## COMMUNITY & ECONOMIC DEVELOPMENT OFFICE

TO: BTC Tech Team Members  
FROM: Ken Braverman, Project Manager, CEDO, City of Burlington Vermont  
DATE: May 11, 2015  
RE: Follow-up correspondence, May 5<sup>th</sup> Meetings

TO: CEDO & Planning Departments  
FROM: Sasaki Associates  
DATE: May 26, 2015  
RE: Technical Team Peer Review – BTC Redevelopment

TO: Burlington CEDO & Planning Department  
FROM: Lucy Gibson, P.E.  
DATE: 27 May 2015  
RE: Technical Team Peer Review – BTC Redevelopment

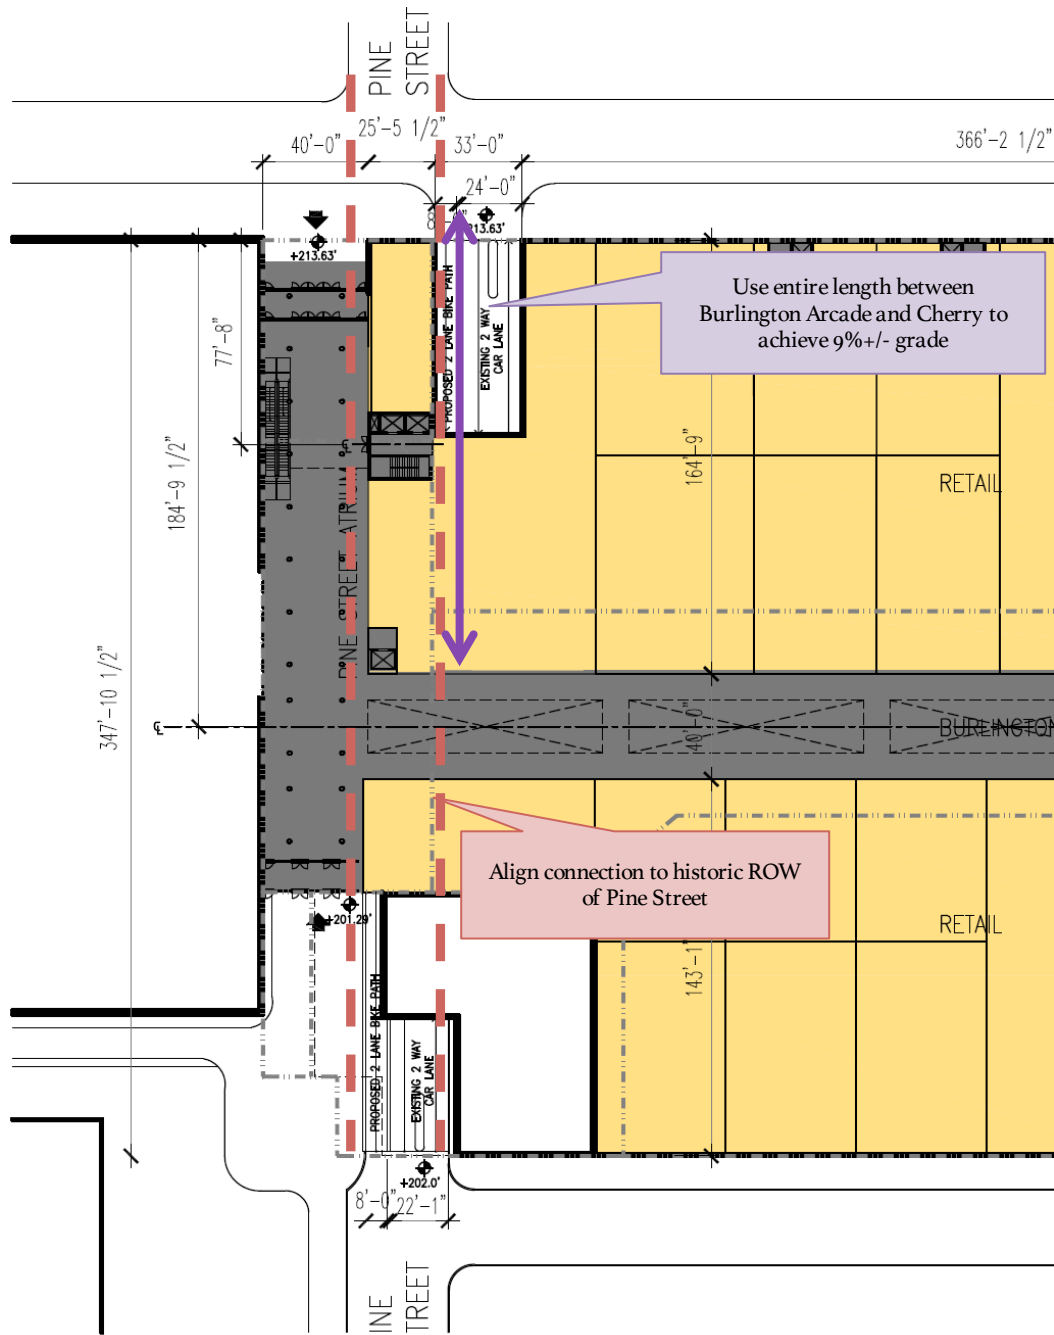
**Bicycle Connectivity.** The bicycle connectivity is provided with a two-way bicycle path along the parking garage access. The proposed path design is not reasonable or safe. The issues include the following:

*Grades.* The grade of the path as it approaches Cherry Street is far too steep, even for vehicle access to the garage. The plans show the change in elevation to be 16.67 feet over a length of 73.75 feet, which equate to an average grade of 22.6%. **Simply put, a bicycle facility CANNOT have grades this steep.** In fact, this grade will even form a significant barrier for vehicles seeking to use this as a connector route. Many drivers will not be comfortable on slopes this steep. The issues of pedestrian use of the bicycle path, and ADA requirements also need to be clarified. A final concern of the plan that will likely require a relatively steep grade at the Cherry Street entrance is the safety of pedestrians traveling along Cherry Street. The plan appears to break the sidewalk connectivity along Cherry Street, which is problematic. Steep uphill grades from parking garages as they approach a busy sidewalk are inherently suboptimal; the drivers are throttling up a steep grade with limited visibility of pedestrians, making conflicts between the two likely.

*Width.* The path is proposed to be 8 feet. This is a minimum width for a shared use path or cycle track, with 10 feet being a desirable target. However, additional width is warranted due to the grades and due to the west edge of the path being aligned against a wall. An additional 2.5 feet of width should be provided where a path is parallel to a wall or other obstruction. Further, additional width is needed in sections where there are grades exceeding 5%. The plans do not show the width of the buffer between the path and the vehicular route; nor any details on the type of bollards proposed to separate the path from the vehicular way.

*Alignment.* The path’s route has several kinks which are too abrupt, even for vehicles, put especially for bicyclists who are traveling at a grade. A preferred alignment is to maintain the historic Pine Street right-of-way, which will provide for a much safer and more efficient intersection at Cherry Street.

*Security.* Riding a bicycle path through an underground garage will be daunting to many riders, making the utility of this route and its success in providing a much needed north-south bicycle connection questionable. To make the path as secure as possible, it should be designed to maximize its use for both bicycles and vehicles, so that bicyclists do not find themselves alone on a dark quiet and constrained route. Therefore, both the vehicle and bicycle connectivity should be emphasized in the design.

**Recommendations.** The Pine Street connector for bicycles and vehicles is unworkable as proposed, primarily due to the steep grades at Cherry Street. The concept of a bicycle route that essentially follows the historic Pine St right-of-way, and has reasonable grades, would be much more desirable for numerous reasons. Providing a vehicular route along Pine Street is also desirable, but it should have a design that includes reasonable grades.

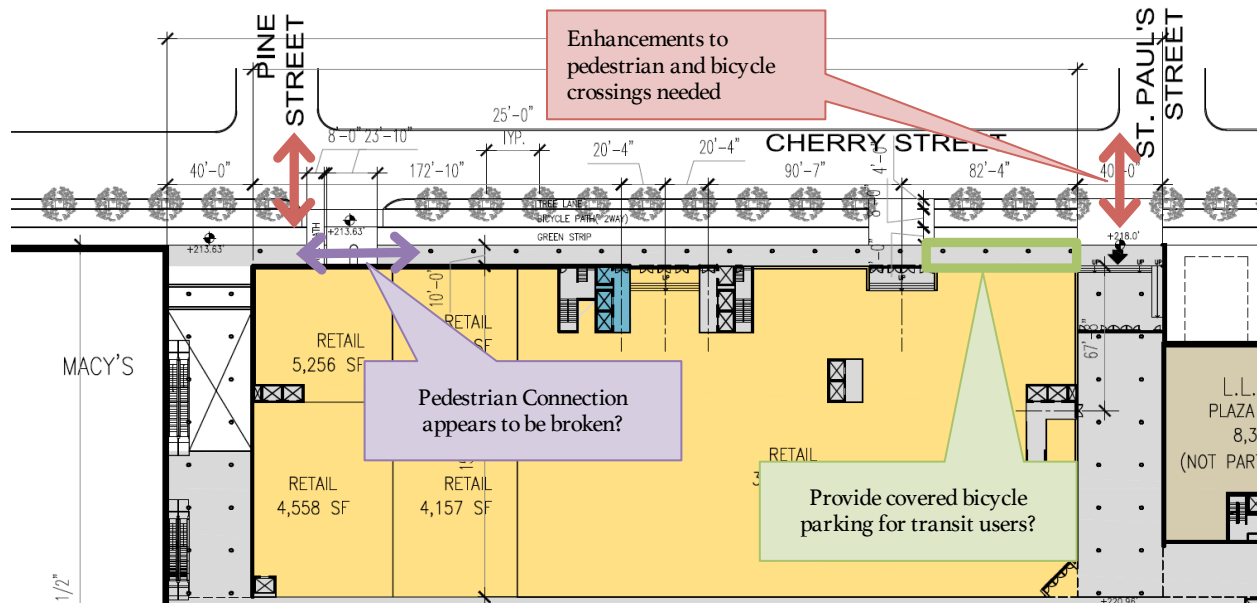
**Cherry St Bicycle Path.** The plan shows a two-way cycle track along the frontage of Cherry Street, which is not consistent with the Burlington Street Design Guidelines, which designate Cherry as a “slow street.” Further, Pearl Street is planned to be the primary east-west bicycle route in this vicinity. The elimination of the bike path on Cherry Street should be eliminated and other options considered, with activation as primary goal. The potential for on-street parking should be considered, given the demand generated by a potential Target store, as well as the multimodal center. Covered bicycle parking could be provided for transit riders accessing the St. Paul transit stops.

**Cherry St Sidewalk.** The plan as shown appears to break the sidewalk continuity on Cherry Street across the parking garage entrance. This will create a huge barrier for walking along this street, impeding its activation.
